**Product Change Notification**

**1. ECR #:** 175646  
**Notification #:** 436

- DCA - DUST CAP ASSEMBLY

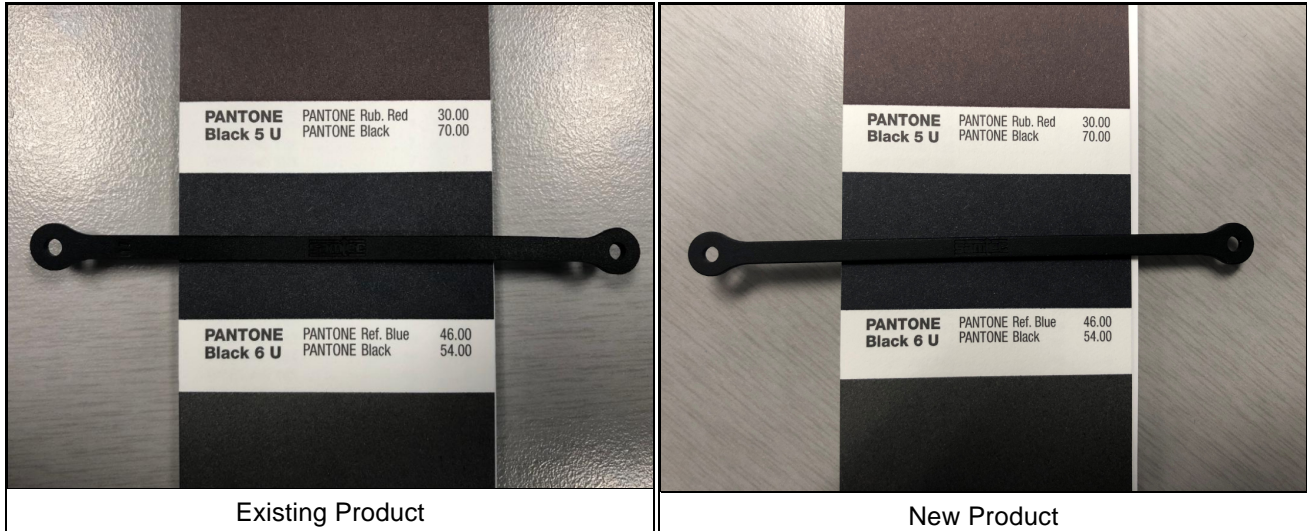
Change strap DCRS-01 material from Natural Rubber to EPDM (Ethylene-Propylene-Diene Monomer). The strap is a component of the series DCA (dust cap assembly)

New and existing product can be identified by Lot Date after the projected implementation date. The appearance of new and existing product is the same, and the PANTONE color code remains at Black 5U. Shown below are images of the existing and updated product, with a color swatch for reference.

The updated product can be used in applications subject to environmental exposure (UV). The product was validated with a UV test per ASTM D1148, passing 96 hours of environmental exposure (UV). The pull force of the new material can also withstand 30% greater pull force before breakage, compared to the existing product.
